**5.1 NO. 54 (LOT: 7; PLAN: 4387) LINCOLN STREET HIGHGATE – PROPOSED ALTERATIONS AND ADDITIONS TO SINGLE HOUSE**

### EXECUTIVE SUMMARY:

The purpose of this report is to consider an application for development approval for proposed alterations and additions to a single house at No. 54 Lincoln Street, Highgate (the subject site) that is heritage listed under the City of Vincent's Heritage List (Management Category A). A location plan is included as **Attachment 1**.

1 DEMOLITION - GROUND FLOOR PLAN  
SCALE 1:100

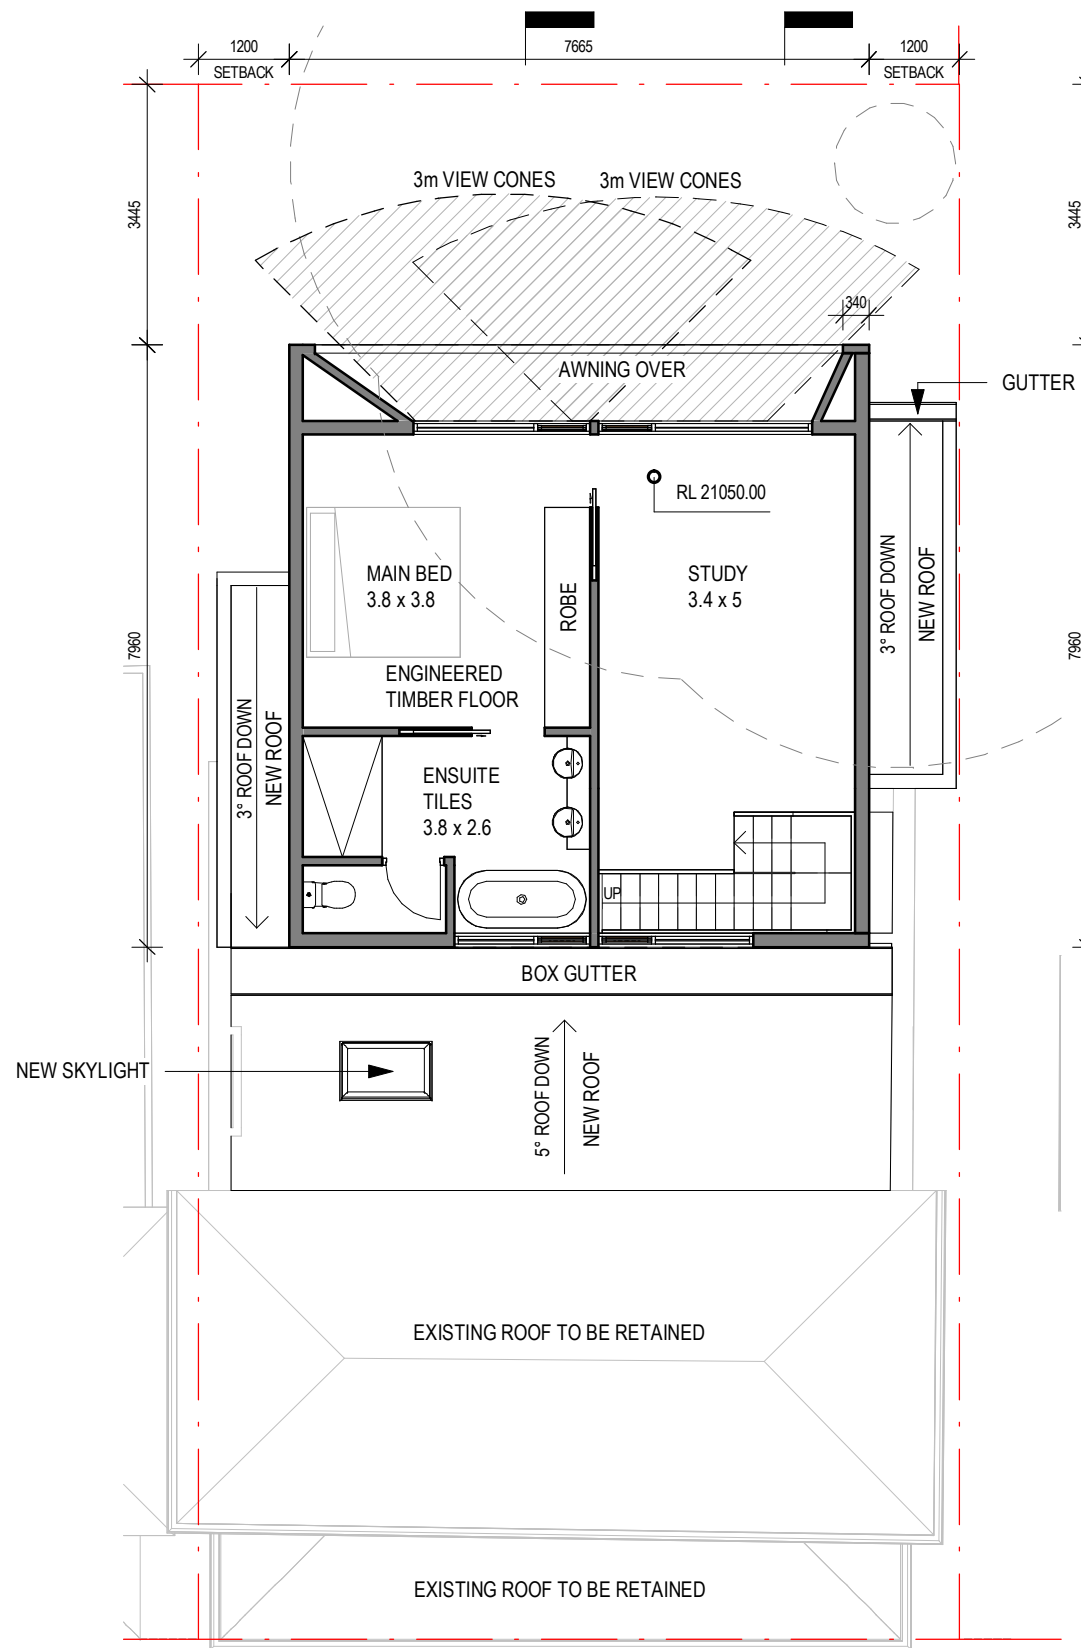
- As a Management Category A place, the proposed alterations/removal of the interior wall from the proposed living to dining room is considered acceptable; however, details of the extent of removal and materials should be provided for the City's consideration.

- As the place is a Management Category A on the Local Heritage Survey, it is recommended that brickwork nibs are retained to each end of the opening as well as to the head of the opening to allow an interpretation that the space was previously two rooms.

Prior to the lodgement of a building permit, amended plans shall be submitted to and approved by the City that show the retention of a frame of brickwork across the ceiling and down the sides of the walls in the demolition of the internal wall between the living and dining rooms. Development and demolition works must be undertaken in accordance with the amended plans approved by the City and prior to use of the approved development, to the satisfaction of the City;

**Lot Boundary Setbacks**

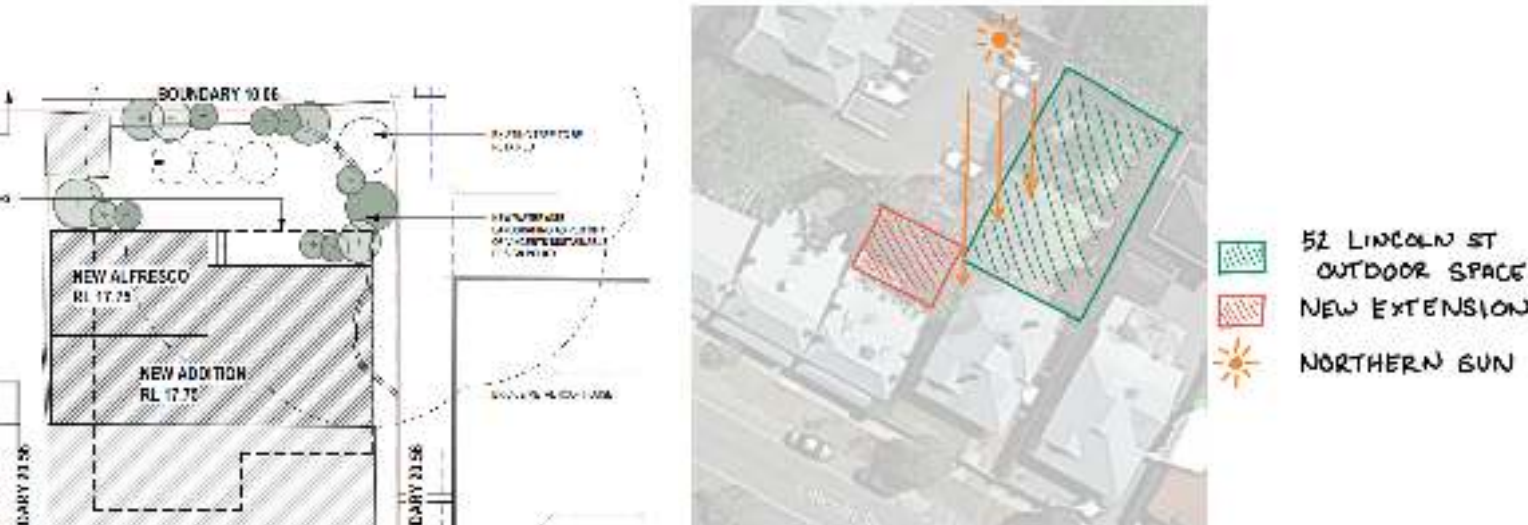
- The western boundary wall height will reduce the amenity of adjoining properties, block sunlight and introduce obtrusively bulky and overbearing mass.
- Reduction to setbacks will impact existing openness and amenity.

The western wall of the extension is stepped in the vertical plane. The lower floor wall follows the line of the existing house which has no material setback as currently built. The upper floor, however, is set back by 1500mm. This ensures that the upper floor does not block light or impact the amenity of the western neighbour. This is demonstrated in the below render showing the location of the western neighbour in relation to the new development (also in application submission documents).
